D206-642-341BL
Job Sheet 192092

Part Name: Replacement Skidtube (Fits LH or RH)

DRAWING NO. D2650	TITLE 206/407 SKIDTUBE ASSEMBLIES	REV. F	DART AEROSPACE LTD ENGINEERING ORDER		D.E.O. NO. D2650-F-1	SHEET NO. SHEET 1 OF 1	SCALE NTS
DRAWN <i>JP</i>	CHECKED <i>A.P.</i>	MFG. APPR. <i>AA</i>	APPROVED <i>##</i>		DE APPR. <i>##</i>		
DATE 12.10.12	DATE 12.10.22	DATE 12.10.22	DATE 12.10.22		DATE 12.10.22

CHANGE C'BORED WELDED CROSSBOLT SPACERS TO SWAGED SPACERS

DETAIL G

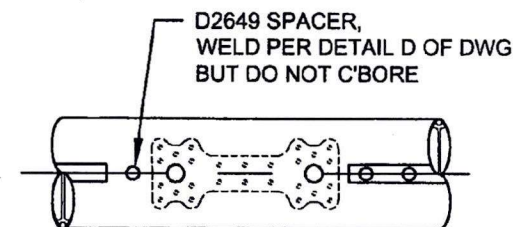
ADD DETAIL G BELOW, WHICH IS THE SAME SECTION VIEW AS DETAIL D OF DWG.

C'BORED HOLES ARE **NOW SWAGED** PER DETAIL G BELOW. FOR THE Ø0.375 HOLE THAT IS NOT C'BORED, WELD PER DETAIL D OF DWG (SEE AMENDED DETAIL B FOR REFERENCE).

AFTER DRILLING AND BENDING ASSEMBLY
PERFORM THE FOLLOWING FOR Ø0.375 HOLES THAT ARE
CURRENTLY C'BORED:

1. INSERT D4720-1 SPACER, 16 PL (-1) OR 17 PL (-3)
OR 19 PL (-5) OR 23 PL (-7)
2. SWAGE TO Ø0.313 X 0.75 DP PER QSI 002
3. TRIM / GRIND FLUSH PER QSI 002
